TECHNICAL INFORMATION

- Subject** ▶ Change of Clamp
- For Models** ▶ JR140D, JR180D, JR3000VT, JR3030T
- Country** ▶ All countries
- Description** ▶ A hole in Clamp for Pin 5.5-6 has been changed in dimensions.

▶ Current	▶ New
 Clamp (Pt. No. 310088-5)	 Clamp (Pt. No. 310138-6)

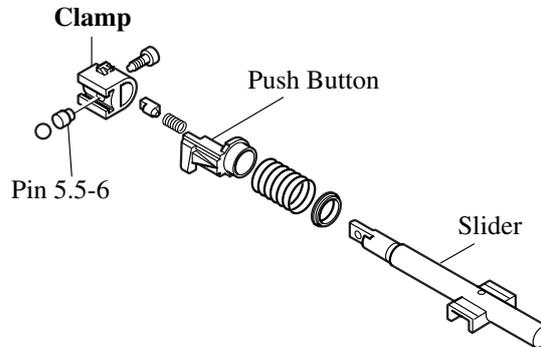
To distinguish new Clamp from current one, new Clamp has a projection as illustrated below.
